Access Compliance Report Public Rights-of-Way (Curb Ramps)

Main Street: WALDEN_ST Cross Street: BRAMFORD_RD Location: NE

ADA ID: RPRK211020173254 Ramp Type: Type 4 - Parallel Initial Pass/Fail: Pass Overall Compliance: No Severity Score: 25

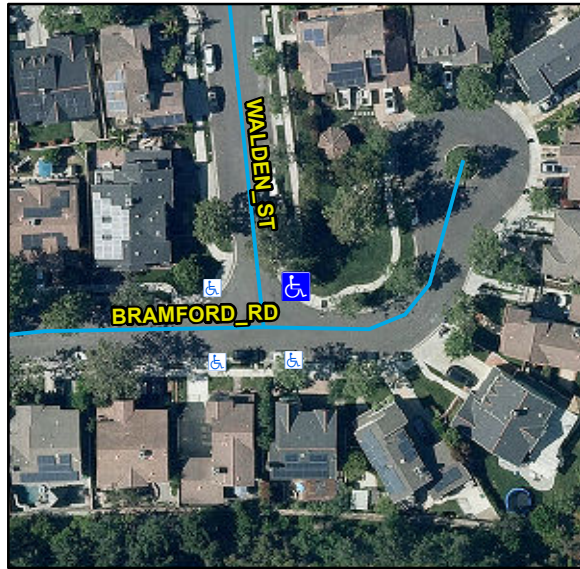
Compliance	Description	Data	Compliance	Description	Data
N/A	Ramp Length LT (in)	117	N/A	Ramp Length RT (in)	120
Yes	Ramp Width LT (in)	54	Yes	Ramp Width RT (in)	53
Yes	Ramp Run Slope LT (%)	4.9	Yes	Ramp Run Slope RT (%)	8.2
Yes	Ramp Cross Slope LT (%)	0.2	Yes	Ramp Cross Slope RT (%)	0.5
N/A	Landing Present	No	No	DWS Provided	No
N/A	Landing Length (in)	N/A	N/A	DWS Contrast	N/A
No	Landing Width (in)	N/A	N/A	DWS Length (in)	N/A
No	Landing Run Slope (%)	N/A	N/A	DWS Full Width	N/A
No	Landing Cross Slope (%)	N/A		DWS Offset Type	N/A
N/A	Landing Movement Obstructed?	No	N/A	DWS Offset Left (in)	N/A
	Landing Movement Type	Curb	N/A	DWS Offset Right (in)	N/A
N/A	Landing Shared	N/A			
N/A	Clear Space	Yes			
N/A	Clear Space To Crosswalk (in)	48			
N/A	Marked Crosswalk 1	No	N/A	Marked Crosswalk 2	No
	Crossing 1 Direction	W		Crossing 2 Direction	S
	Marked Crosswalk 1 Width (in)	N/A		Marked Crosswalk 2 Width (in)	N/A
N/A	Ramp Inside Crosswalk 1	N/A	N/A	Ramp Inside Crosswalk 2	N/A

Crossing 1 Slope (%)	1.8		Crossing 2 Slope (%)	3
	Crossing 1 Cross Slope (%)	0.7		Crossing 2 Cross Slope (%)	0.2
Yes	Gutter Ponding	No	No	Curb Slope	13.7
Yes	Gutter Lip Height (in)	0		Road Run Slope (%)	1.3
No	Gutter Run Slope (%)	5.7		Road Cross Slope (%)	2.1
Yes	Gutter Cross Slope (%)	1.6	No	Perpendicular Joint Present	No
Yes	Overall Surface Condition	Acceptable			
	Cross Gutter Present?	No		Spandrel Present?	No
	Replace Cross Gutter?	N/A		Replace Spandrel?	N/A

Remove & Replace Curb Ramp With Two New Directional Ramps or Equivalent. Remove & Replace Gutter.
